BAKERSFIELD CITY SCHOOL DISTRICT
FRANKLIN ELEMENTARY SCHOOL MODERNIZATION
BAKERSFIELD, KERN COUNTY, CALIFORNIA

Job No. 1316
Appl. No. 15-6
File No. 03-122910

ADDENDUM NO. #02
NOTICE TO CONTRACTORS FIGURING THIS WORK

1 ADD DEMO

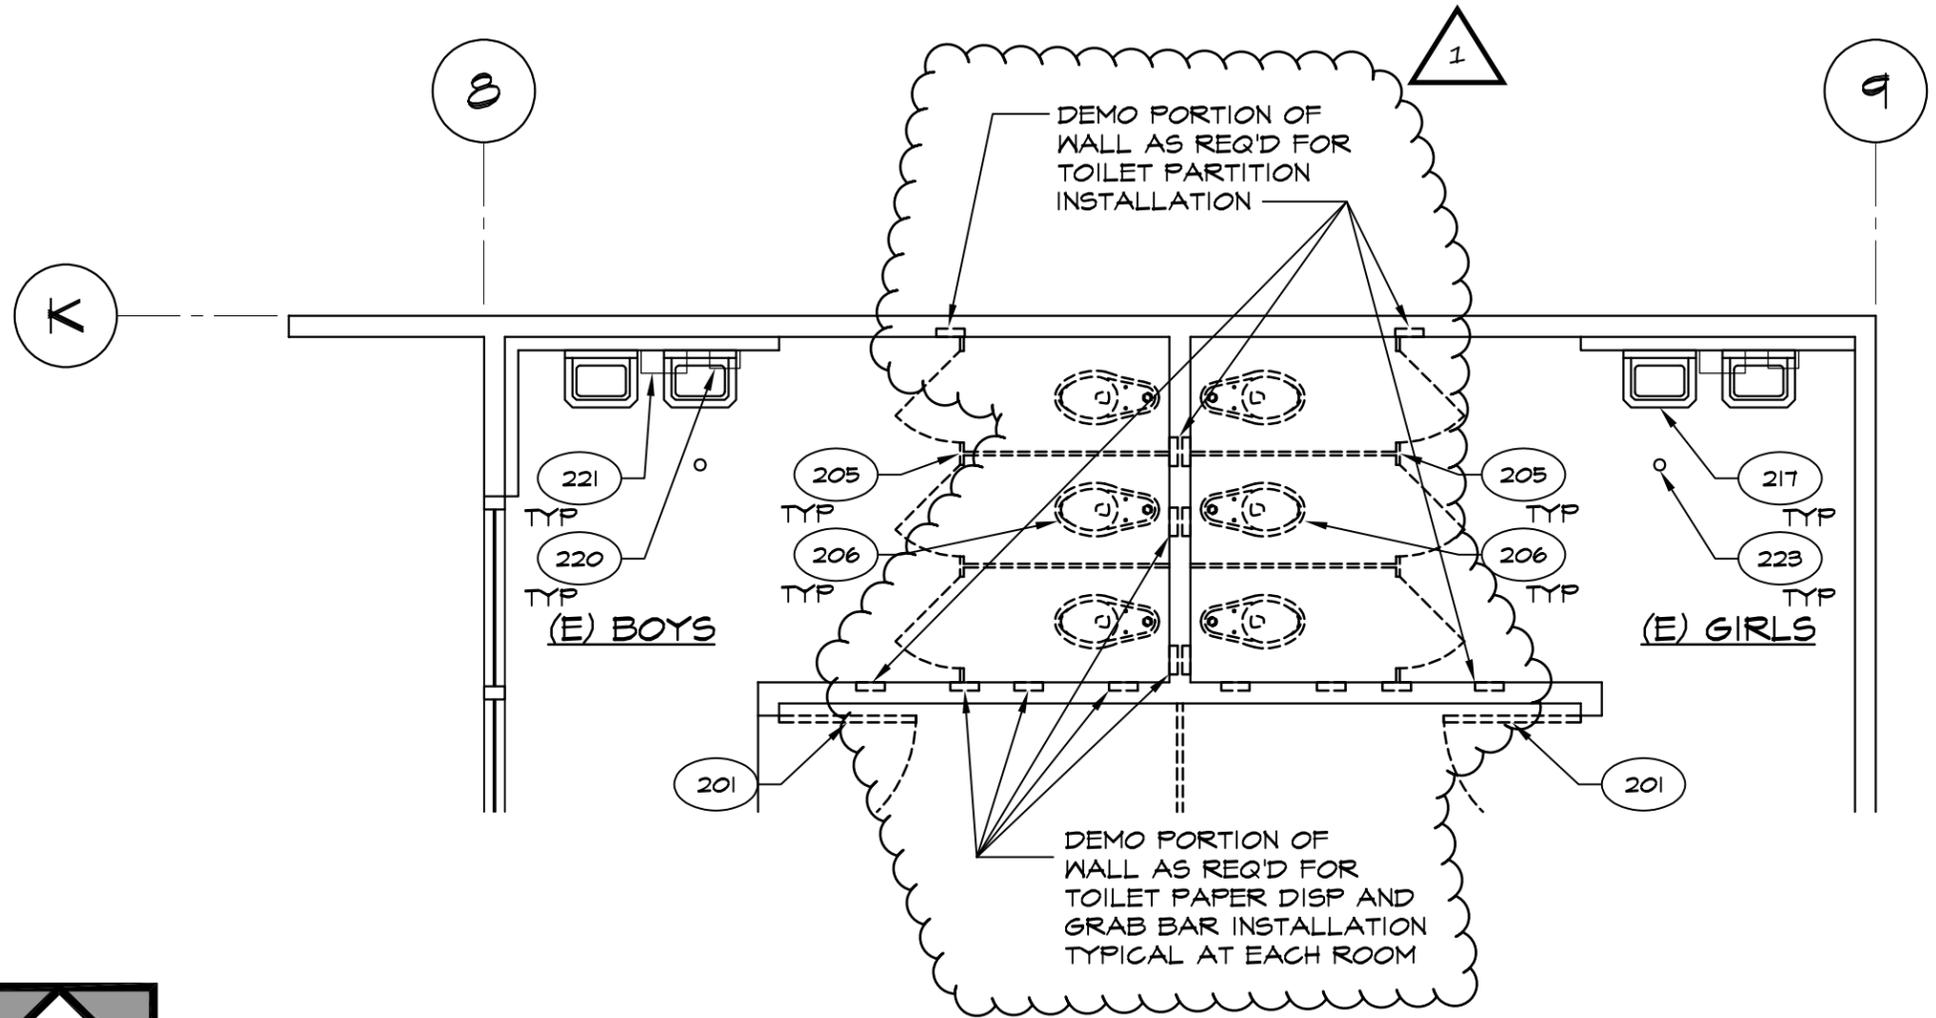
- 2-1) Refer to DSA Approved Drawings, Sheet No. A2.1 FLOOR PLAN BUILDING C, ROOMS 301 BOYS & 302 GIRLS;
- a. ADD: To Partial Plan (B), demolition of miscellaneous wall finishes as indicated per attached Drawing No. 01.

1 ADD WALL PATCH
 AND SLAB INFILL

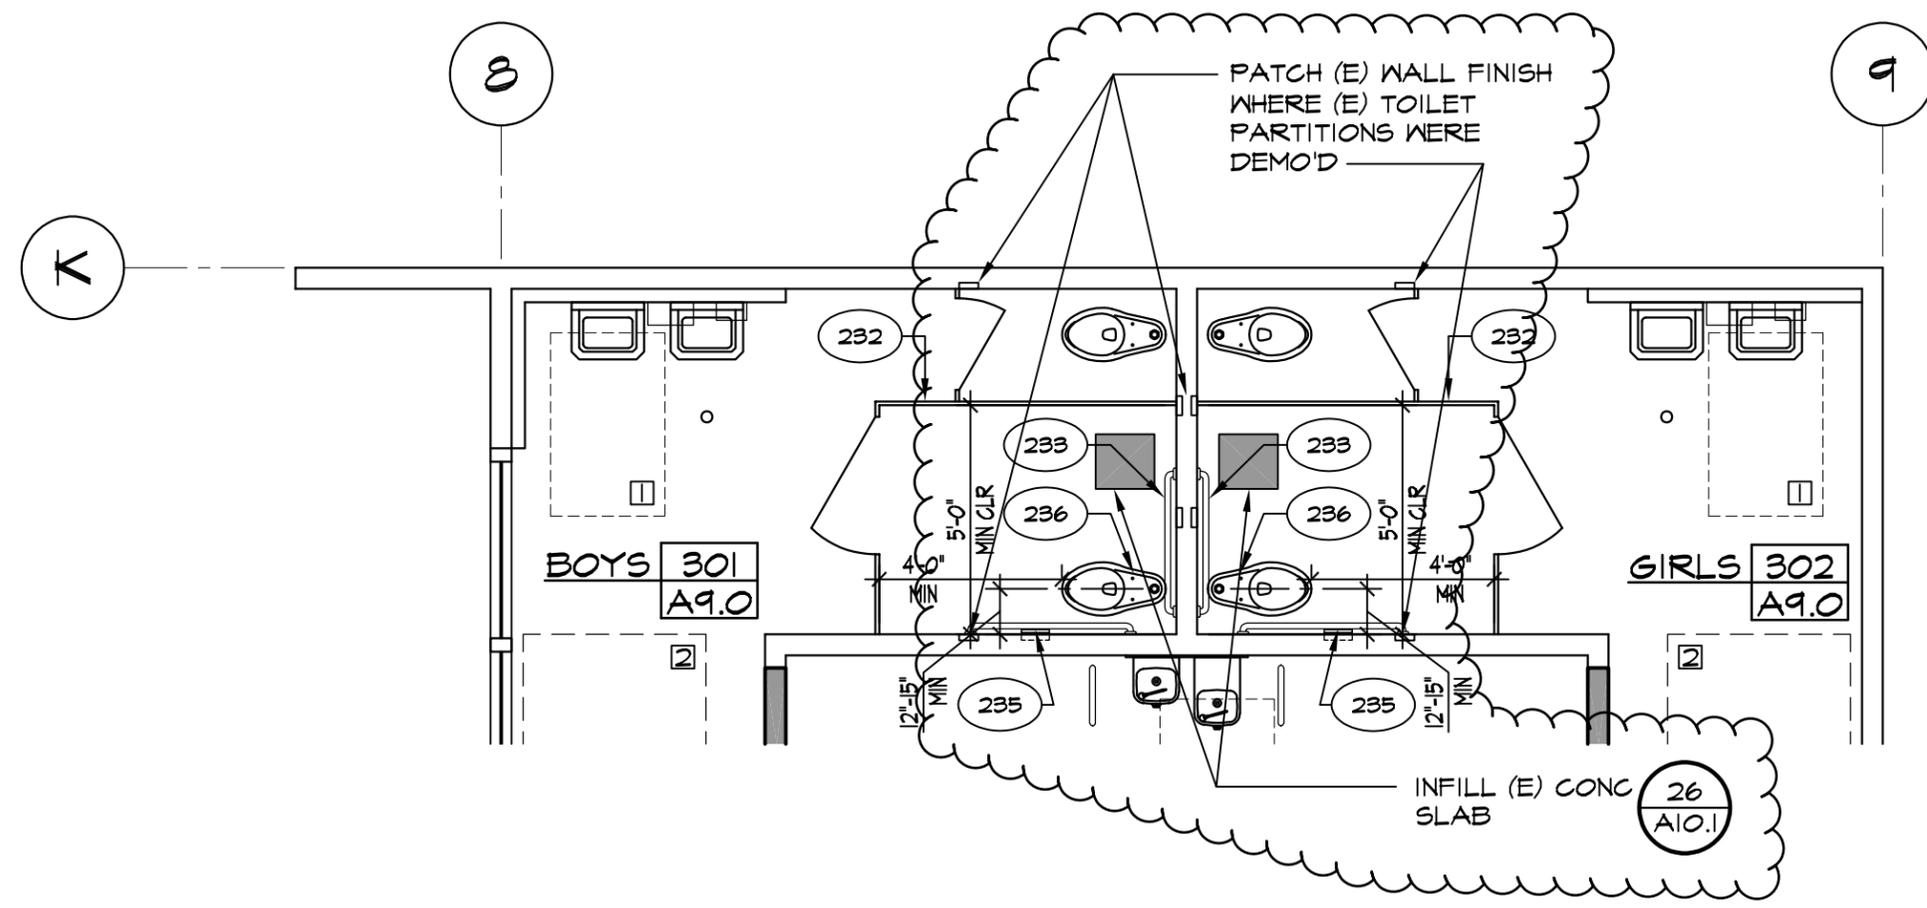
- b. ADD: To Partial Plan (A), concrete slab infill where water closets are being demolished as indicated per attached Drawing No. 02.
 - c. ADD: To Partial Plan (A), patching of miscellaneous wall finishes as indicated per attached Drawing No. 02.

NOTE:
 PATCH (E) WALL FINISH AS
 REQ'D FOR INSTALLATION OF
 TOILET PARTITIONS, GRAB BARS,
 TOILET PAPER DISP

1 ADD WALL PATCH

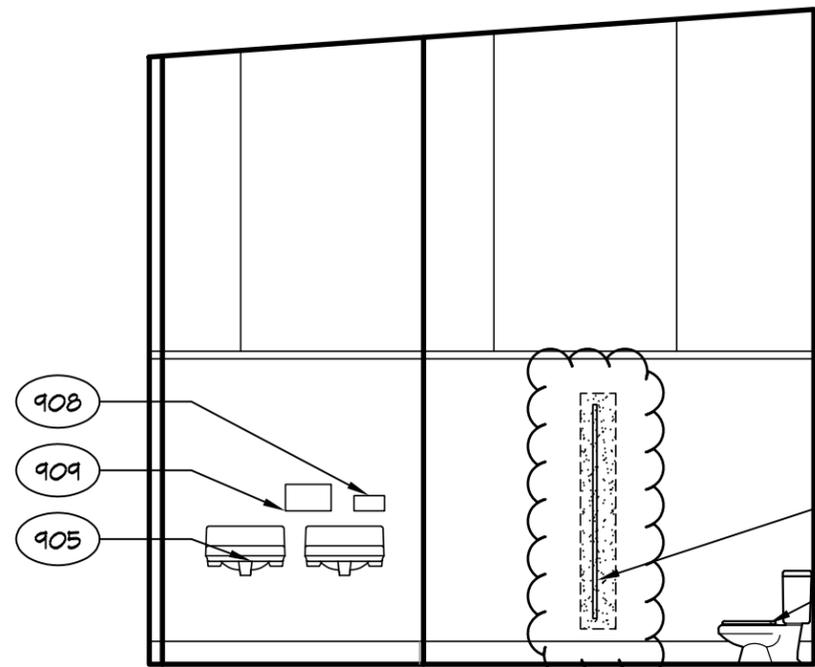
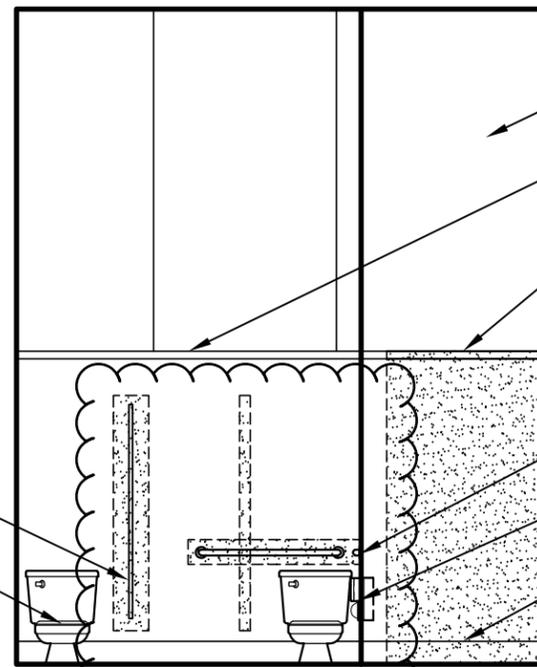
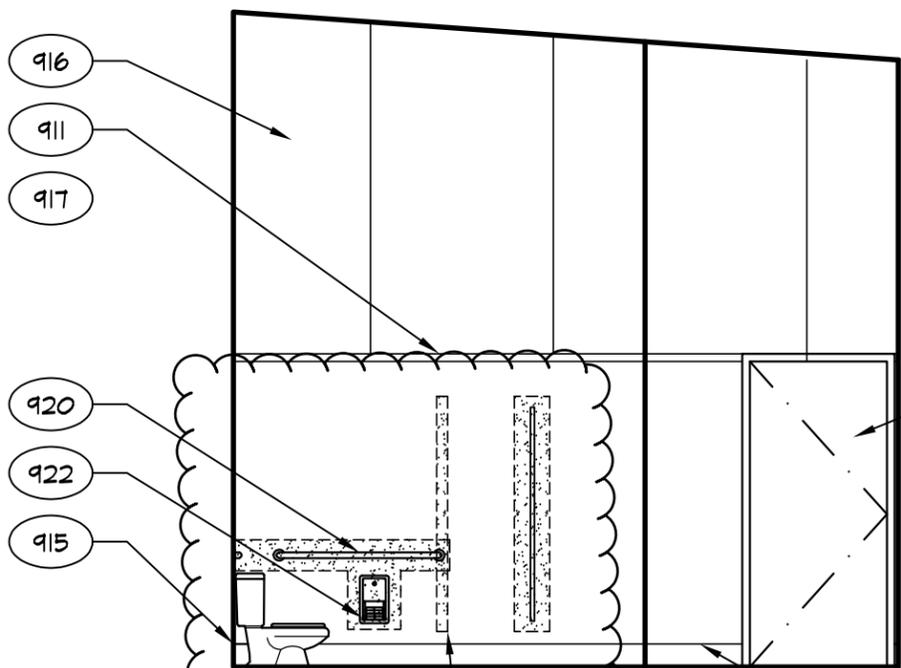
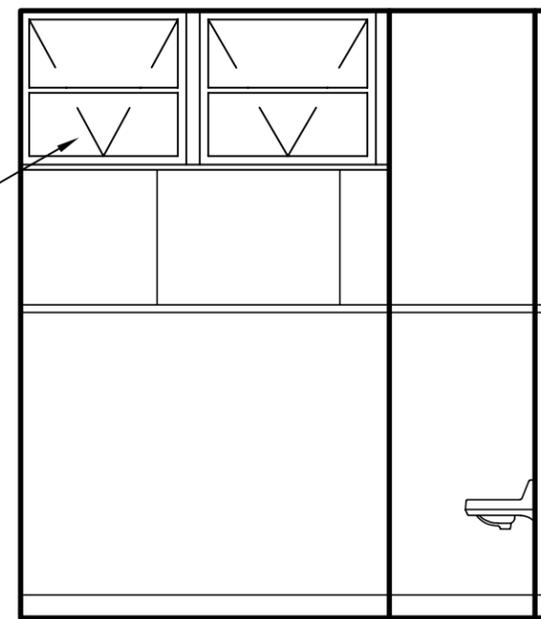
- b. ADD: Patch & match (E) wall finish for installation of toilet partitions, grab bars, and toilet paper dispensers as indicated per attached Drawing Nos. 03 and 04.

NOTE:
PATCH (E) WALL FINISH AS
REQ'D FOR INSTALLATION OF
TOILET PARTITIONS, GRAB BARS,
TOILET PAPER DISP

1 ADD WALL PATCH

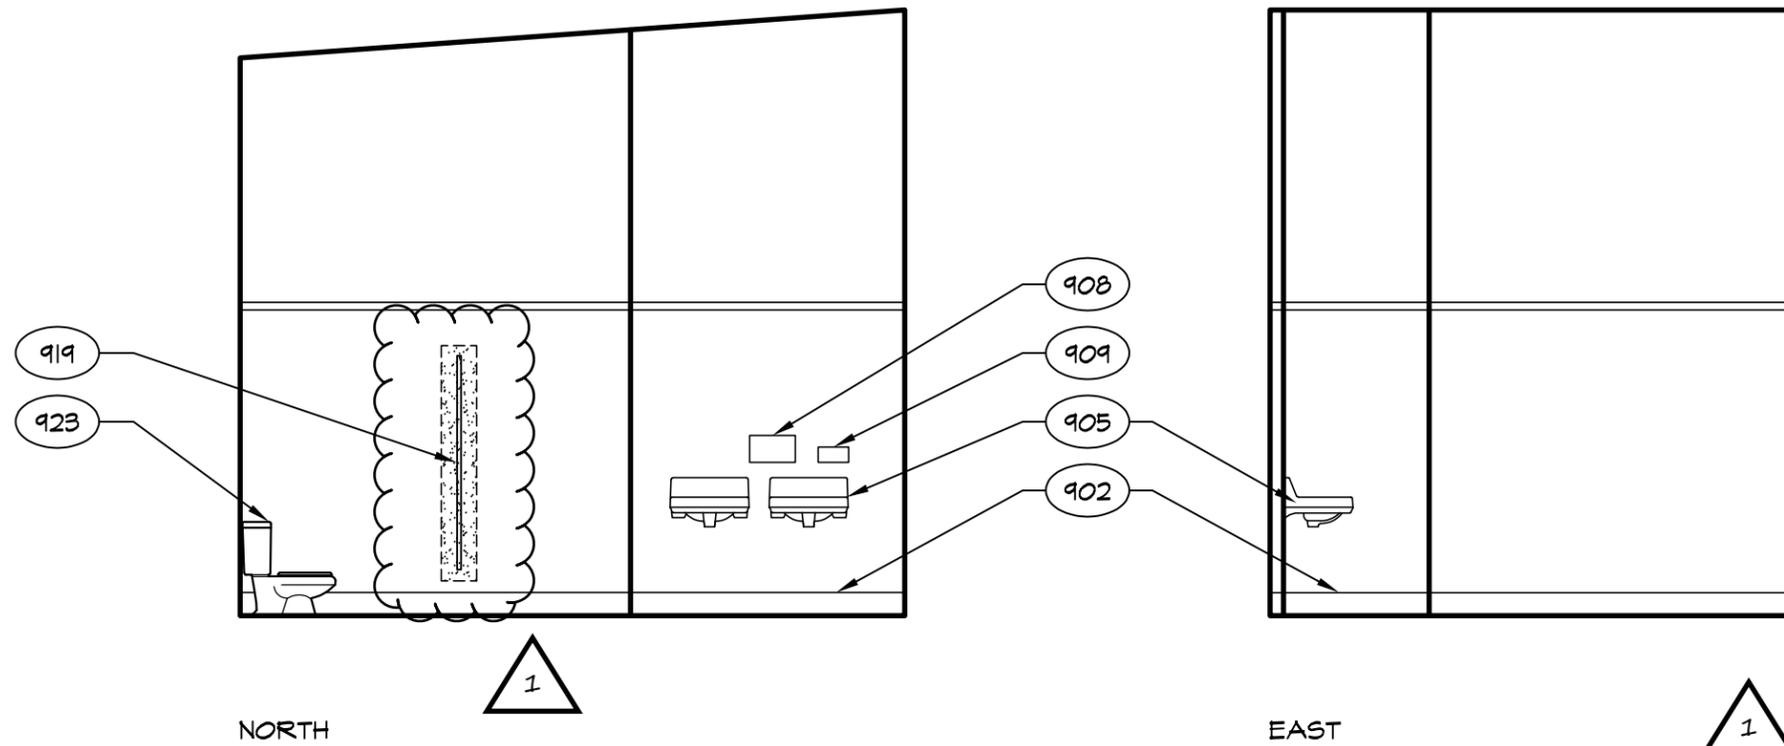
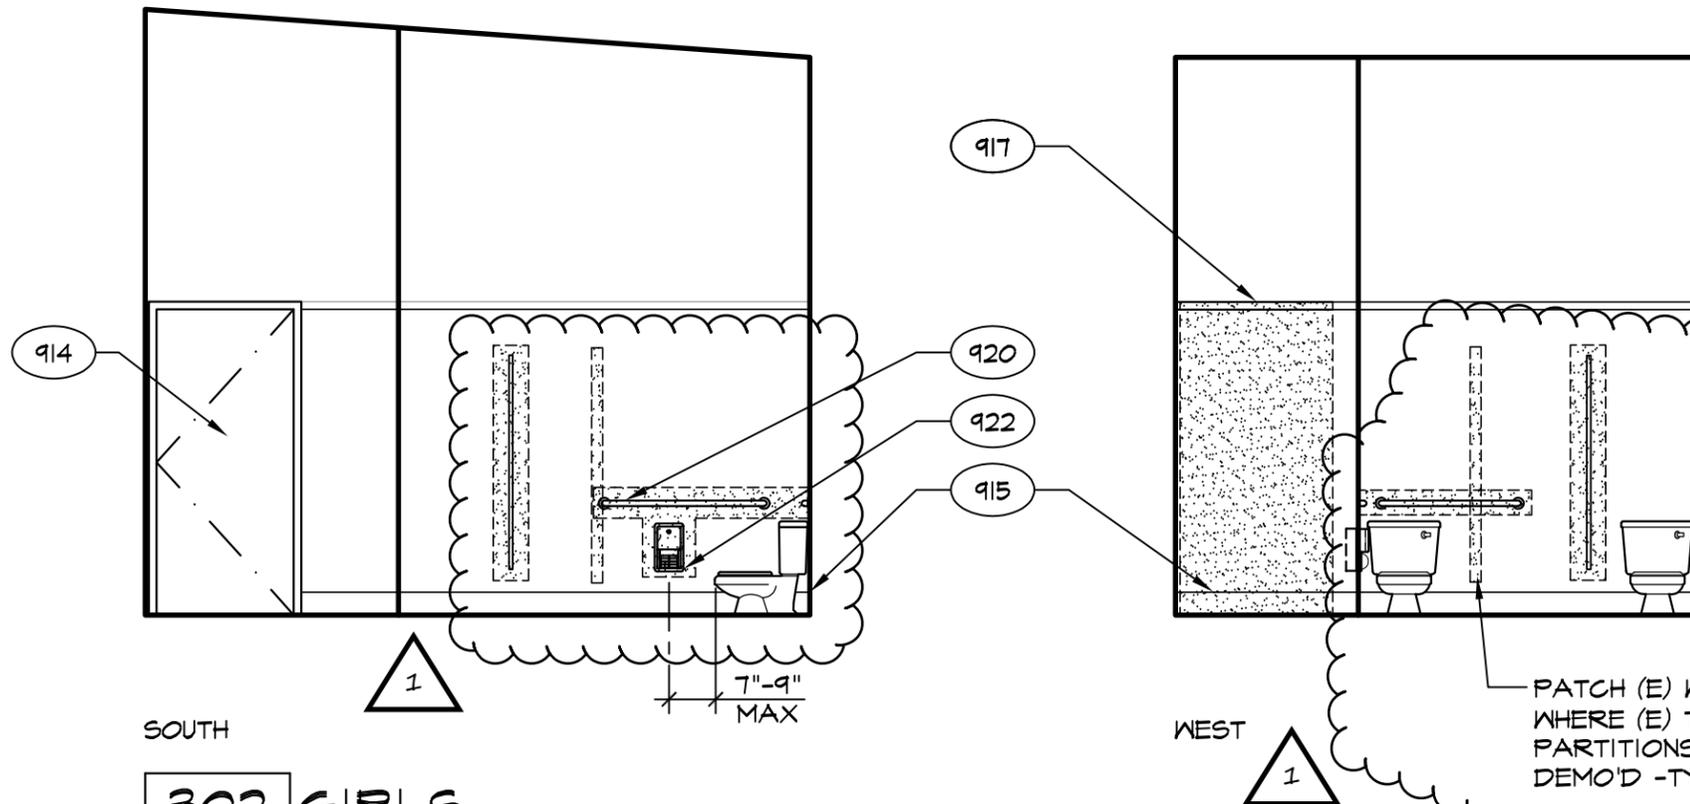
NOTE:
 PATCH (E) WALL FINISH AS
 REQ'D FOR INSTALLATION OF
 TOILET PARTITIONS, GRAB BARS,
 TOILET PAPER DISP

1 ADD TILE PATCH

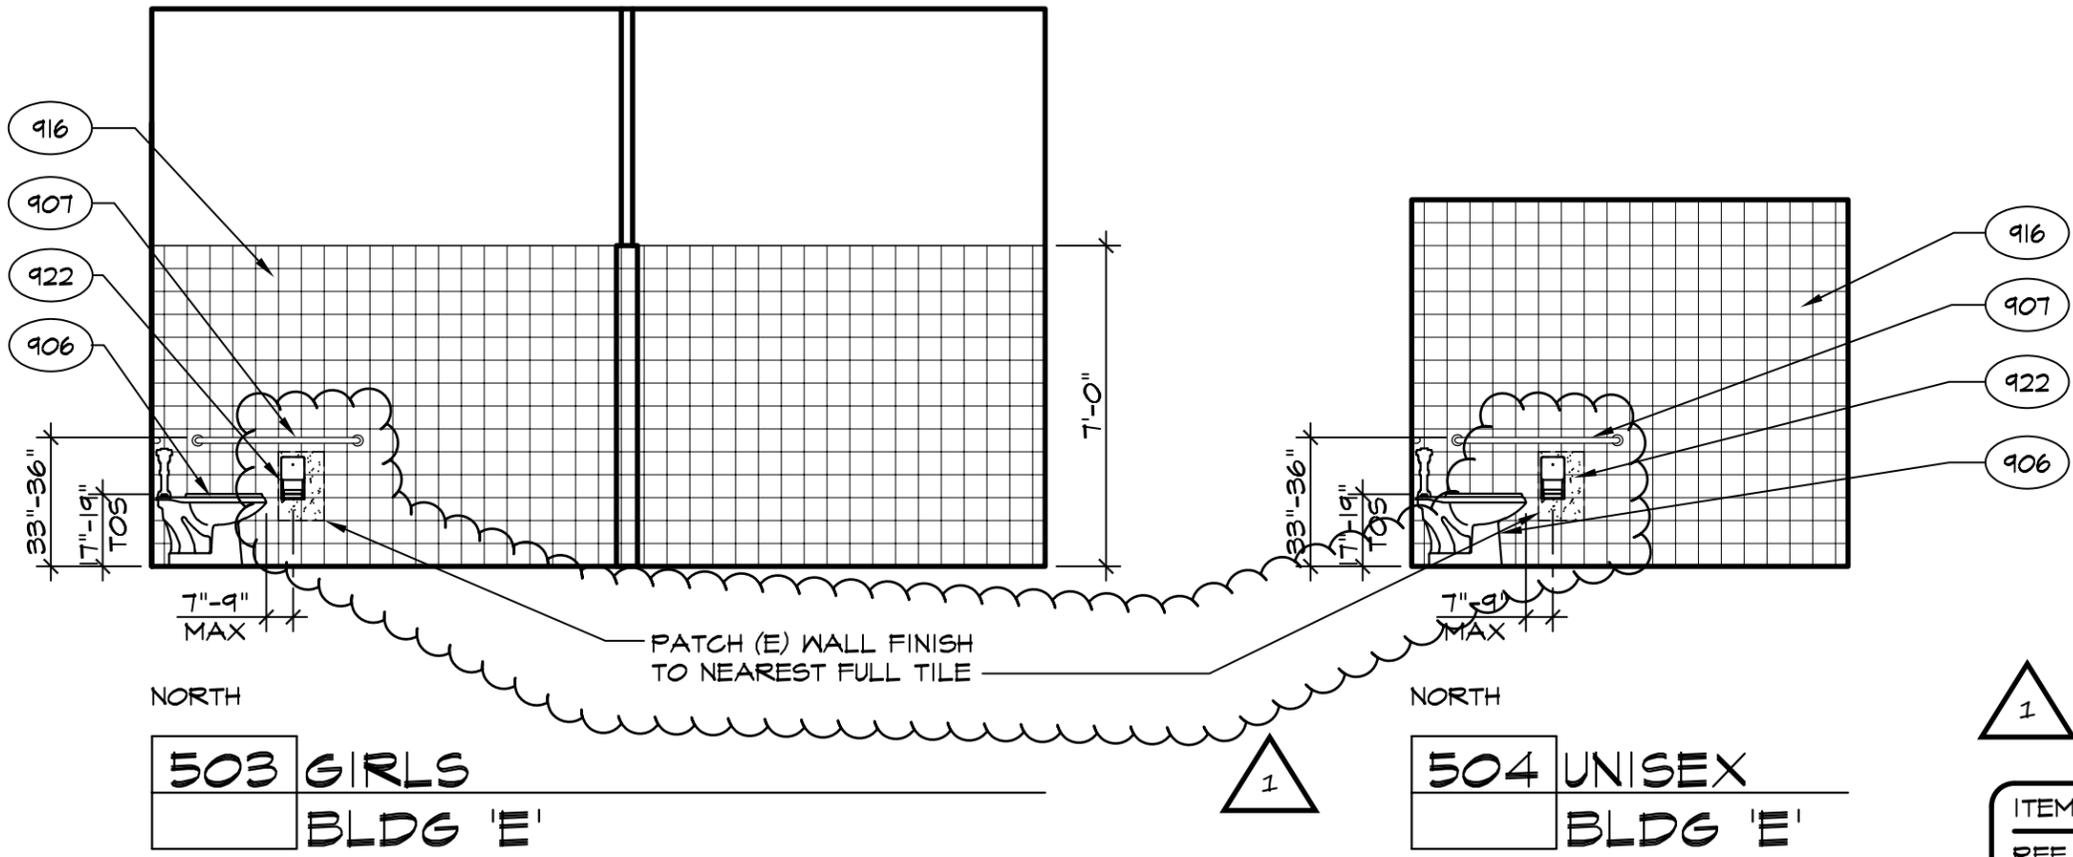
- 2-3) Refer to DSA Approved Drawings, Sheet No. A9.1 INTERIOR ELEVATIONS;
- a. ADD: At 503 Girls North and 504 Unisex North, patch & match (E) ceramic tile for installation of toilet paper dispenser as indicated per attached Drawing No. 05.
